**Folderno.** 8089/3/2017

**applicant:** ROMANIA ASSOCIATION Bankwatch

**Object Type:** Administrative act until agreement No.2 / 2016

## **Ratio of technical expertise Judicial specialization Ecology and the Environment**

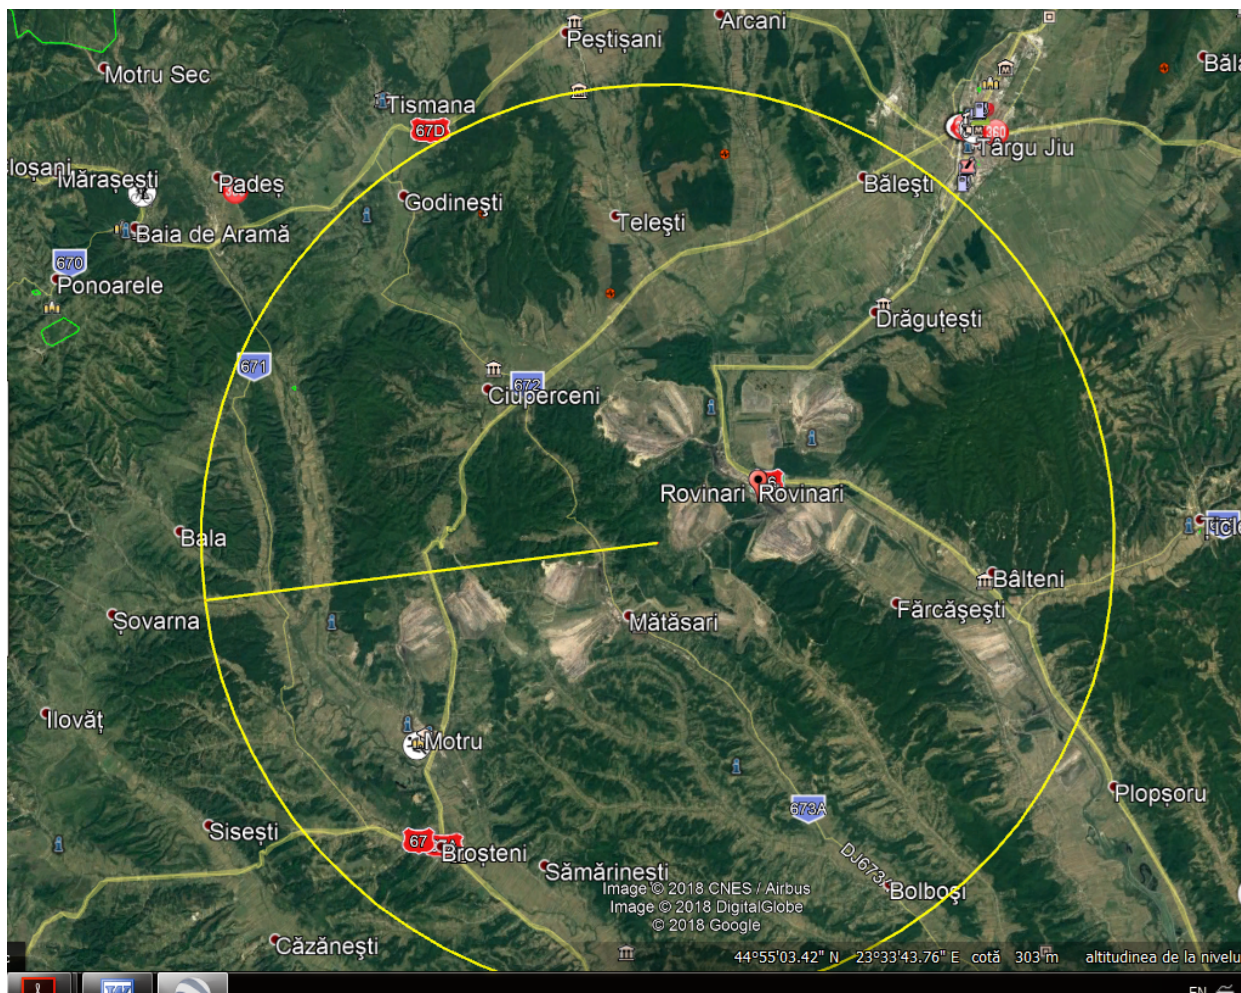
In the EIA report has described the real impact of enlargement for Rosia career might generate on the environment, so that between 11 to 17 March 2018 have made numerous trips to area to be cleared and in villages affected the extraction, transport and storage of the coal. Based on the findings described below actual impact that the project will generate on the environment and protected areas in the vicinity.

Based on the report said Study Environmental Impact Assessment, such as the impact on the groundwater level can be felt up to 10 km away from the mines, and the image below, it can be concluded that following the expansion of coal mines in Gorj county, the water level will drop greatly slot.
